CITY OF ALBUQUERQUE

Re: Bogan Brothers Painting
3435 Vassar Dr., NE
Traffic Circulation Layout
Engineer's/Architect's Stamp **6-6-16** (G16-D150)

Based upon the information provided in your submittal received ~~XX-XX-16~~, the above referenced plan cannot be approved for Building Permit until the following comments are addressed:

Figure 1. Mini Clear Sight Triangle

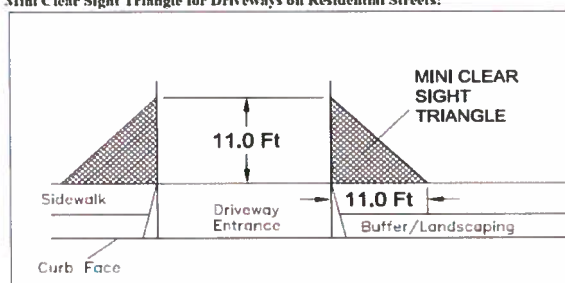
5. Service vehicle and/or refuse vehicle maneuvering must be contained on-site; provide a copy of refuse approval.
6. Please provide a sight distance exhibit (see the *Development Process Manual, Chapter 23, Section 3*). Please add this detail for entrances/exits on Vassar Dr.

7. Please add the following note to the clear sight triangle: "Landscaping and signage will not interfere with clear sight requirements. Therefore, signs, walls, trees, and shrubbery between 3 and 8 feet tall (as measured from the gutter pan) will not be acceptable in this area."
8. Unused curb cuts must be replaced with sidewalk and curb & gutter. A build note must be provided referring to the appropriate City Standard drawing.
9. All broken or cracked sidewalk must be replaced with sidewalk and curb & gutter. A build note must be provided referring to the appropriate City Standard drawing.
10. Please include two copies of the traffic circulation layout at the next submittal.

TCL

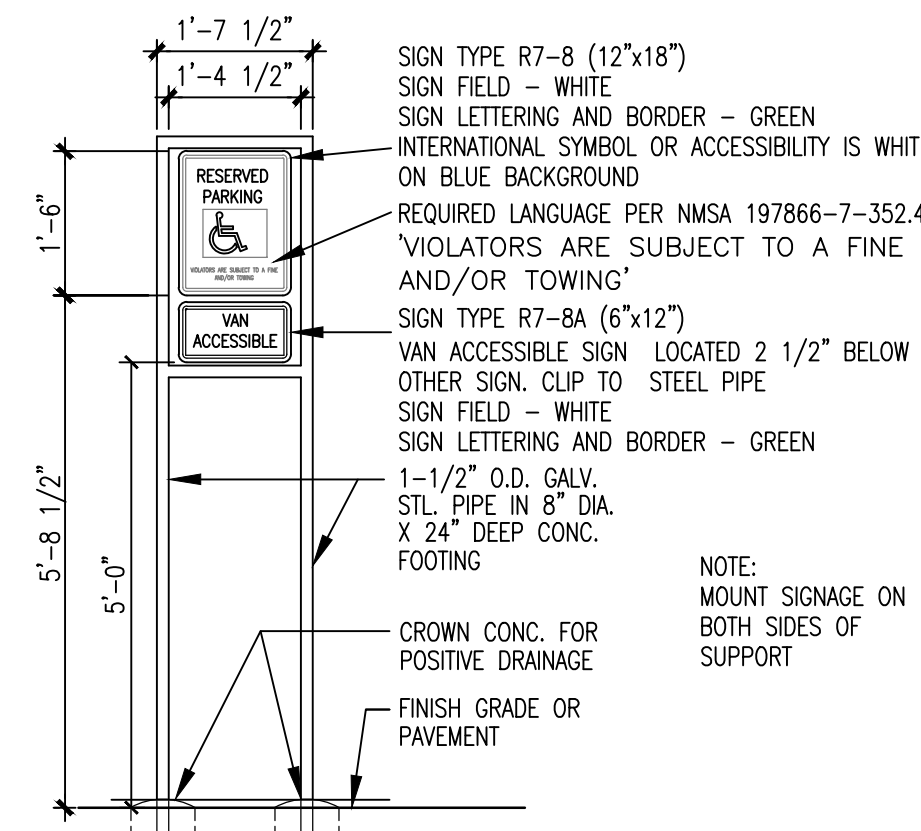
1. Please dimension all sidewalks, drive pads, ADA ramps and anything that influences the parking and circulation on the site.
2. Per DPM, a 6 ft. wide ADA accessible pedestrian pathway is required from the public sidewalk to the building entrances. Please clearly show this pathway and provide details.

3. Per DPM, a 6 ft. wide ADA accessible pedestrian pathway is required from the HC parking stall access aisles to the building entrances. Please clearly show this pathway and provide details. Please dimension the access isle.

4. Provide a min 6" or max 8" high concrete barrier curb or other acceptable barrier between landscaping and parking areas and/or drive aisles. Please call out detail and location of barrier curb.
